MANDATORY SERVICE BULLETIN

MSB 42-149

MSB 42NG-095

Actions to prevent Passenger Door Separation: Installation of Placards, AFM Procedure update and Inspection/Data Gathering.

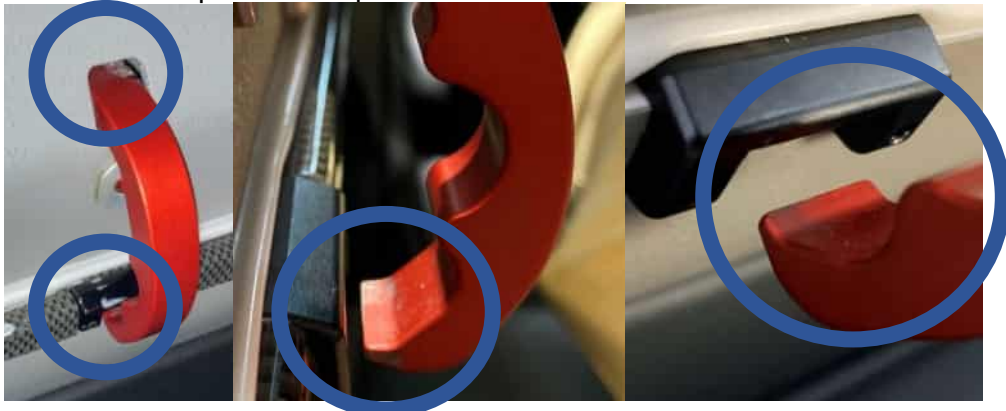
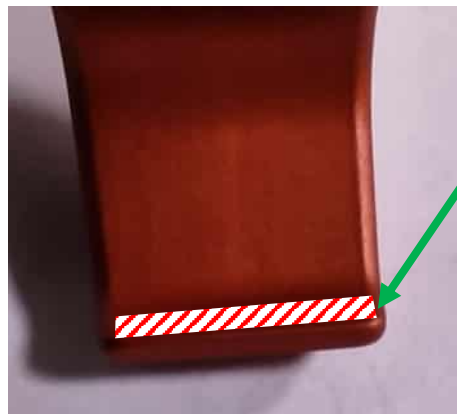
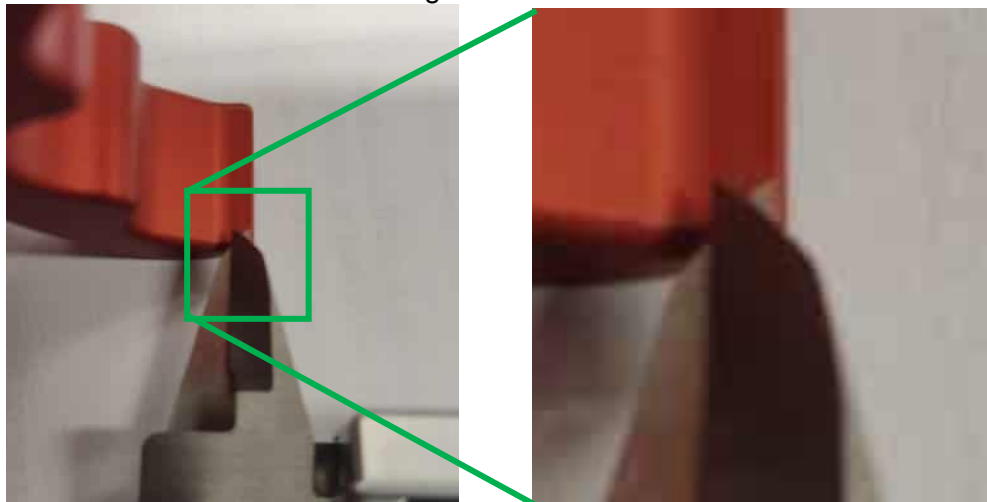
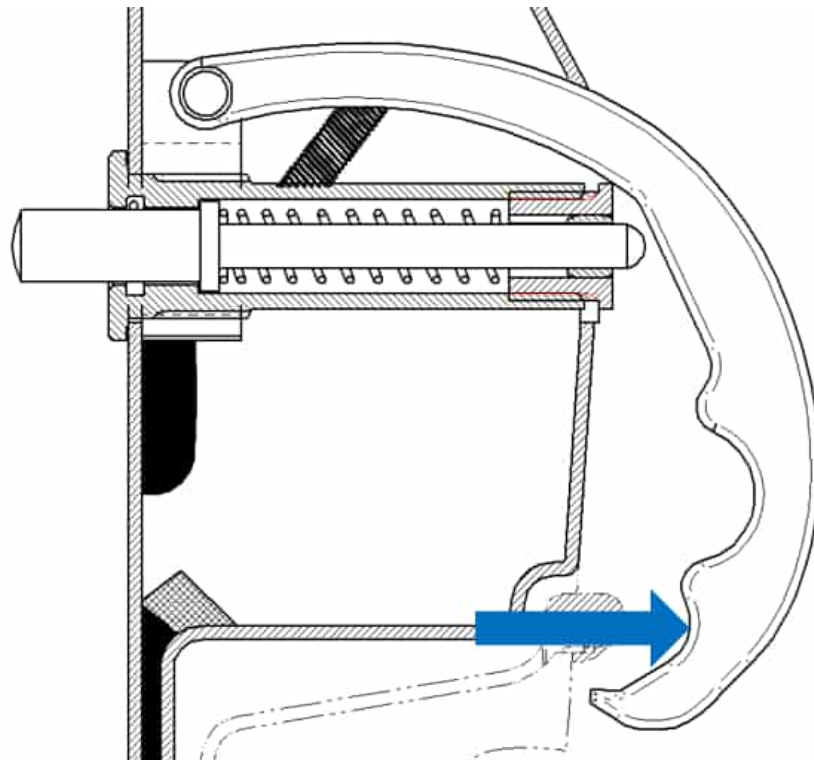
- 6 Examine the Safety Hook for signs of wear, corrosion and poor condition:
- Record the finding on the execution report in Appendix B.
 - There must be no deformation or cracks.
 - Pay particular attention to the contact area of the Actuation Pin.
 - Grooves in the Safety Hook must be less than 2 mm deep.

- Pay particular attention to the hook end of the Safety Hook.
 - The hook end must not be bent.
 - Not acceptable:

- There must be no corrosion on the contact area to the Retaining Bracket.
- Examples of acceptable conditions:

- Examine the tip of the Safety Hook for wear:
 - Wear of edges of Safety Hook:
 - The width of the tip of the Safety Hook must be greater than 10.5 mm.

- The engaging surface of the Safety Hook is the flat surface at the tip of the Safety Hook.
 - It must be free from steps and ridges.
 - Scratches or uniform wear of surface protection are permitted.

- Measure the width of the engaging surface.
 - The width must be greater than 1.5 mm.

- Measure the maximum thickness of the Safety Hook at the location of the engaging surface, perpendicular to the engaging surface.
 - The thickness must be greater than 2.5 mm.
 - The maximum variation of measured thickness over the width of the Safety Hook must be less than 0.2 mm.

- Measure the minimum thickness of the Safety Hook at the location of the engaging surface, perpendicular to the engaging surface.
 - The minimum thickness must be greater than 1.5 mm.
 - The maximum variation of this value over the whole width must be less than 0.2 mm.

- The edge of the engaging section of the Safety Hook that is facing towards the Retaining Bracket must be free from ridges.

Replace Safety Hook, if

- any of the Safety Hook dimensions measured in this step are not within the given tolerances, or
- corrosion is found, or
- deformation, grooves, ridges or steps.

8 Data Collection: Identify the version of the Retaining Bracket:

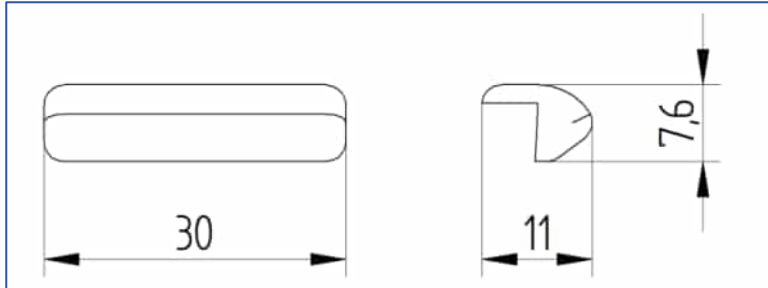
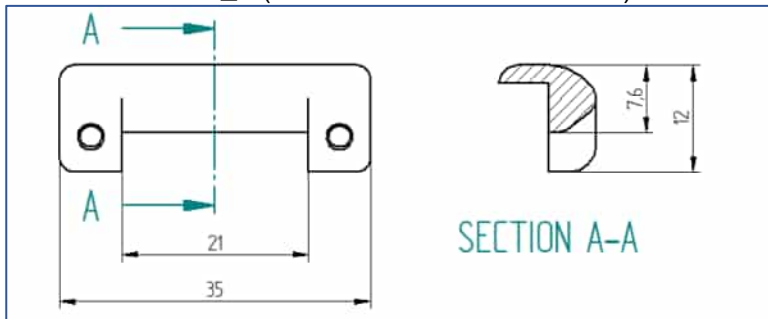
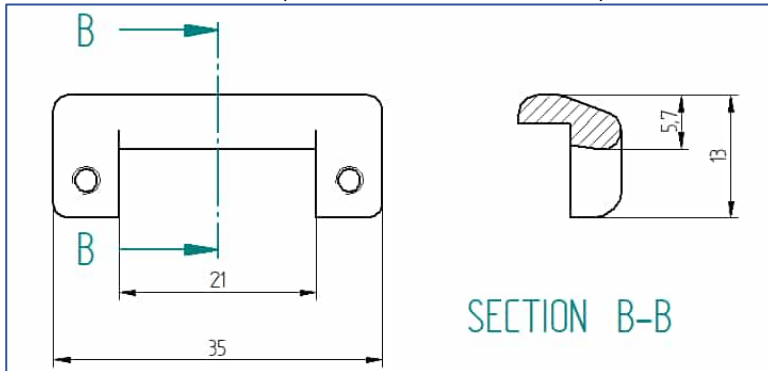
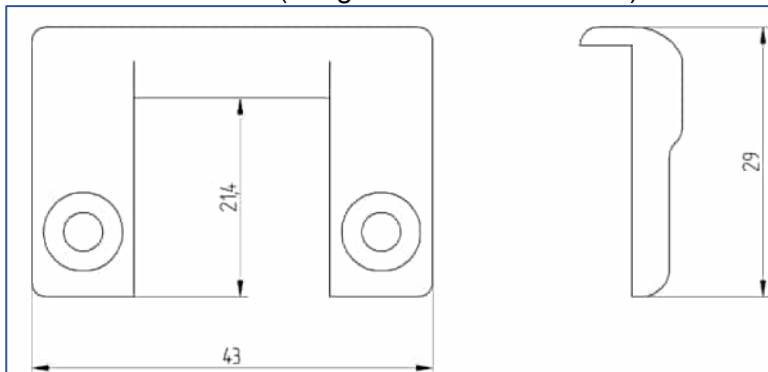
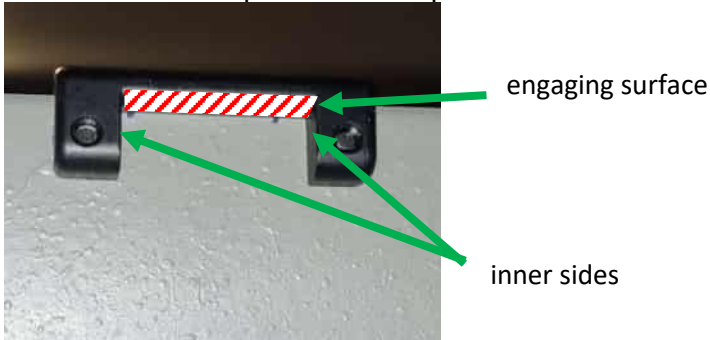
| 9 | <p>If Retaining Bracket DA4-5200-00-69 is installed (refer to step 8.):</p> <ul style="list-style-type: none"> • Replace the Retaining Bracket according to MSB 42-083/MSB 42NG-014 (refer also to EASA AD 2010-0235). • Record replacement of the retaining bracket on the execution report in Appendix B. |
| 10 | <p>Examine the Retaining Bracket for signs of wear, corrosion and poor condition.</p> <ul style="list-style-type: none"> • There must be no corrosion on the Retaining Bracket. • Wear at the inner sides of the Retaining Bracket: maximum 0.5 mm per side. • The engaging surface of the Retaining Bracket and the edge of the engaging surface facing the Retaining Bracket must be free from steps and ridges. • Scratches or uniform wear of surface protection are permitted.  <ul style="list-style-type: none"> • The thickness of the Retaining Bracket measured perpendicular to the upper surface must be greater than <ul style="list-style-type: none"> ○ 4 mm (for Retaining Bracket DA4-5200-00-69_02 (extended with undercut), or ○ 6 mm (for all other Retaining Brackets, refer to Step 8).  <ul style="list-style-type: none"> • The width of the Retaining Bracket (measured i.a.w. picture below) must be greater than 10 mm. <ul style="list-style-type: none"> ○ Variation of the width over the whole length of the Retaining Bracket must be less than 0.2 mm. |

Replace the Retaining Bracket, if:

- any of the Retaining Bracket dimensions are not within the given tolerances, or
- if corrosion is found, or
- the wear limit is exceeded, or
- steps or ridges are found.

11 Examine if the Safety Hook properly engages in the Retaining Bracket:

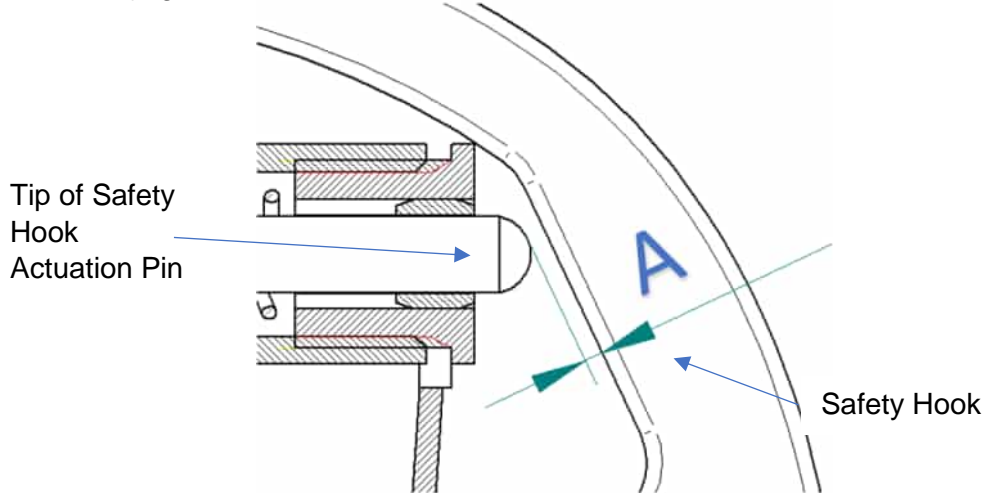
The Safety Hook Actuation Pin must not be pressed during this step.

- Close and latch the Passenger Door.
- Unlatch the Passenger Door from the outside and pull on the outer Passenger Door Handle.
 - The Safety Hook must engage in the Retaining Bracket and prevent the Passenger Door from further opening.
- Pull on the outer Passenger Door Handle with 15 ± 1 kg / 150 ± 10 N.
 - The Safety Hook must not disengage but must remain properly engaged in the Retaining Bracket
- Record the check results on the execution report in Appendix B.

If the Safety Hook disengages, identify the cause, record it on the execution report in Appendix B **and** contact Diamond Aircraft Industries GmbH.

12 Data Collection: Measure the following dimensions:

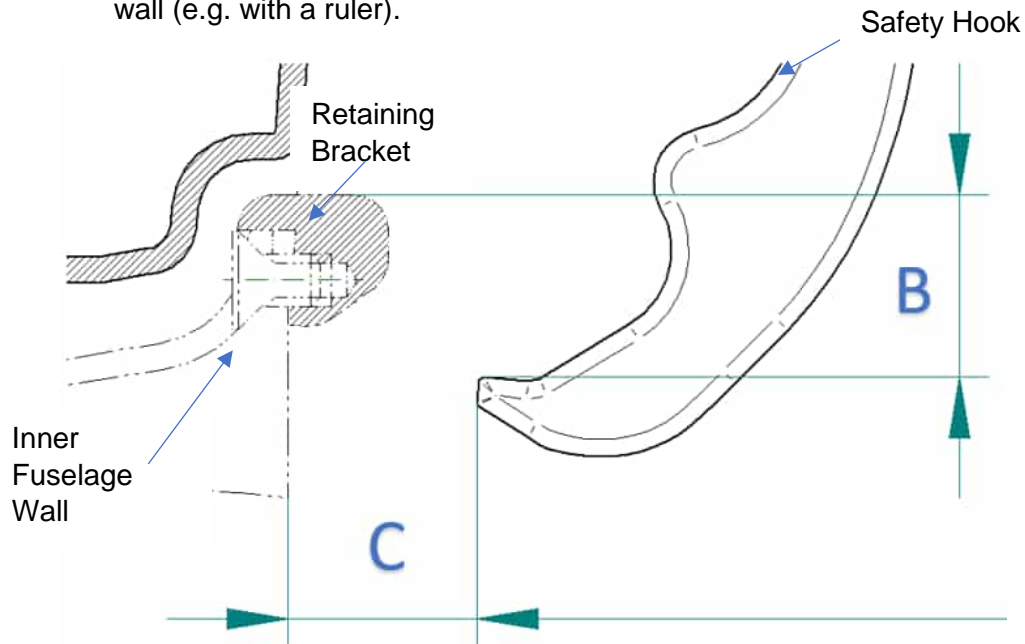
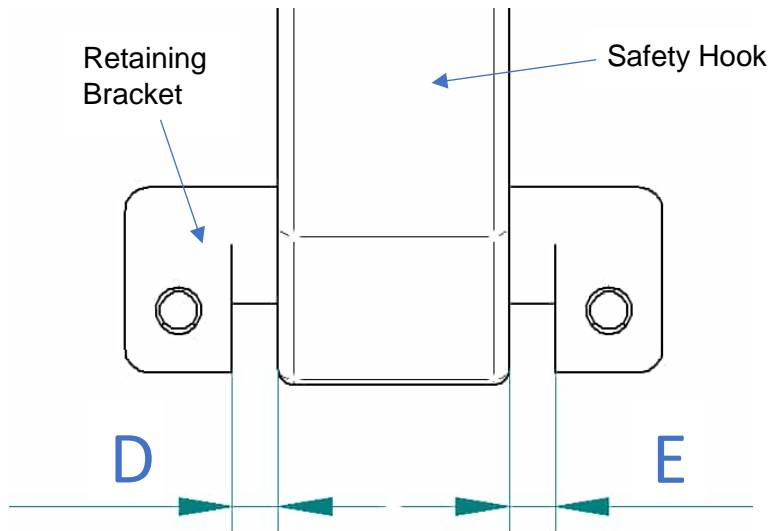
- Close and latch the Passenger Door.
- Record the measurements on the execution report in Appendix B.
 - Dimension A: distance of Actuation Pin to Safety Hook in resting position (e.g. with a feeler gauge).

- Dimension B: distance between top surface of the Retaining Bracket to top surface of engaging section of Safety Hook in resting position of Safety Hook (e.g. with a ruler).
- Dimension C: horizontal distance between tip of Safety Hook and fuselage wall (e.g. with a ruler).

- Unlatch the Passenger Door and push the Passenger Door open, engaging the Safety Hook into the Retaining Bracket, apply slight pressure to the Passenger Door to keep the Safety Hook engaged during the measurement.
- Record the measurements on the execution report in Appendix B.
 - Dimension D (e.g. with a ruler).
 - Dimension E (e.g. with a ruler).

18 If MÄM 42-097 is installed (refer to step 15), examine the condition of the gas spring of the latching mechanism:

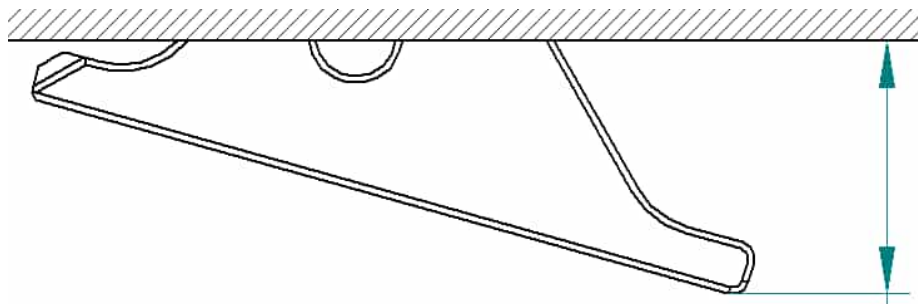
- Open the Passenger Door.
- Move the Passenger Door handle into unlatched position.
- Slowly move the Passenger Door handle towards the latched position and measure the distance at which the Passenger Door handle snaps into latched position by itself (measured at the outermost point of the lever, refer to sketch below).

- If the distance is less than 20 mm, replace the compression gas spring. Refer to AMM Section 52-10. Repeat this step after replacement.
 - If the distance is less than 20 mm after replacement of the gas spring, the cause is high friction in the latching system.
 - Examine the latching bolts according to step 22.
 - If the reason for high friction in the latching system cannot be found, replace the latching system i.a.w. AMM section 52-10.
 - Repeat this step after parts replacement.
- Record the measured distance and any replacements on the execution report in Appendix B.

19 If MÄM 42-097 is installed (refer to step 15), examine the adjustment of the gas spring in the Passenger Door latching mechanism.

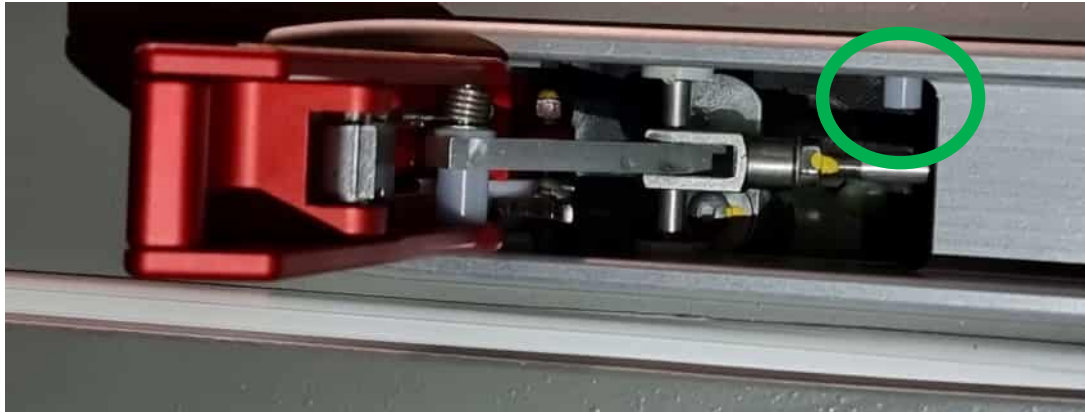
The gas spring inside the door handle must push the door handle into the latched position firmly against the stop:

- Open the Passenger Door.
- Move the Passenger Door Handle to the latched position.
- Examine, if the door handle is pushed into the mechanical stop inside the door handle mechanism (marked in the pictures below).
- If the Passenger Door Handle is not pushed against the mechanical stop by the gas spring, adjust the gas spring (refer to AMM section 52-10) and repeat this step.
- Record whether the gas spring was adjusted properly on the execution report in Appendix B.

23 Measure the extension length of the latching bolts of the Passenger Door.

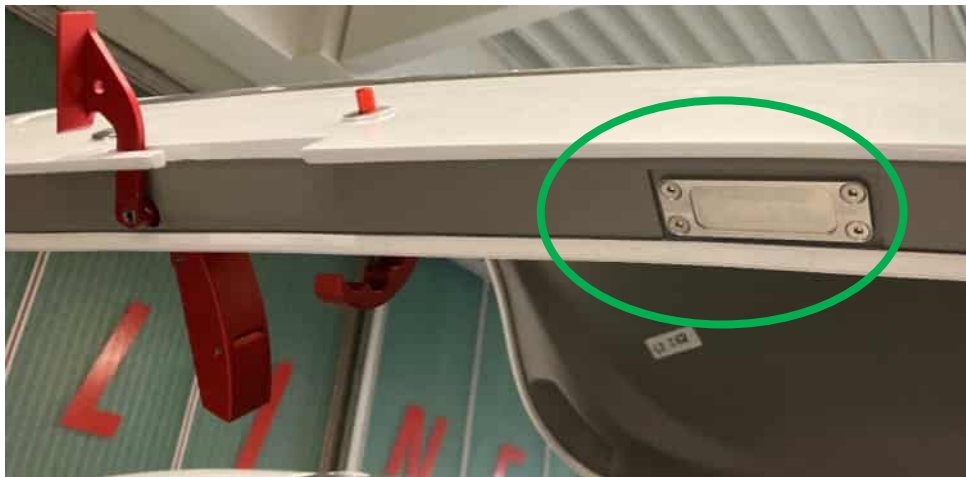
- Measure the extension length at the bottom of the front and rear latching bolts in mm. Refer to pictures below.
 - The front latching bolt extension length must be 40 ± 2 mm.

- If MÄM 42-687 is **not** installed, the rear latching bolt extension length must be 40 ± 2 mm.
 - If the extension length is out of tolerance, adjust the latching bolt if possible, or replace latching bolt if necessary.

- After adjustment or replacement repeat this step.
 - If MÄM 42-687 is installed, the rear latching bolt extension length must be 44 ± 1 mm.
 - If the extension length is out of tolerance, adjust the latching bolt if possible, or replace latching bolt if necessary.

- If the extension length is out of tolerance, adjust the latching bolt if possible, or replace latching bolt if necessary.
 - After adjustment or replacement repeat this step.

- 28 If MÄM 42-097 is installed (new latching mechanism, refer to step 15), install placard D60-1133-10-09 to the upper side of the inner canopy handle.

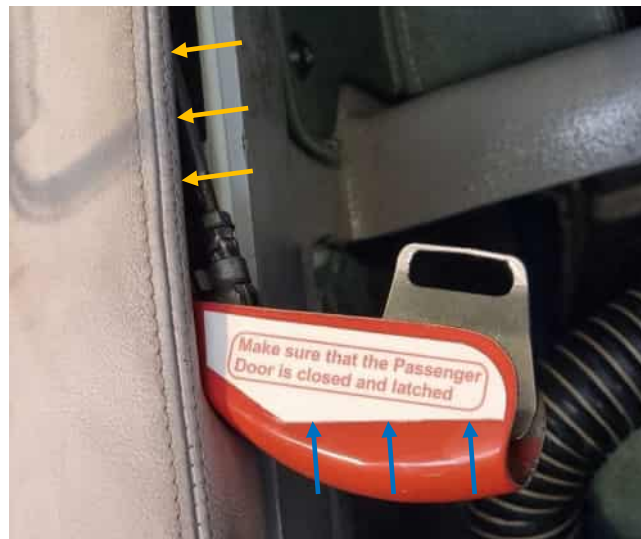
- Unlatch the canopy.
- Clean the canopy handle from dirt and grease.
- Align the placard with the straight edge and position it in spanwise direction so that it is completely visible from the pilot's perspective if the canopy handle is in the unlatched position.
- The placard must disappear when the canopy handle is in the latched position.

Appendix A - Placards**Fabrication instruction**

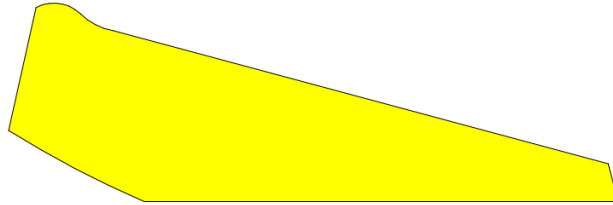
1. Print the placards with waterproof ink or with a laser printer according to scale (see bottom right corner).
2. Attach a clear adhesive tape over the printed side of the placard.
3. Attach a film type double sided adhesive tape on the reverse side of the printed placard.
4. Cut around the edge of the placard.
5. Attach the placard according to the instructions of the Work Instruction above.

WARNING
Do NOT touch safety hook during flight
Do NOT close the door
if found open during flight
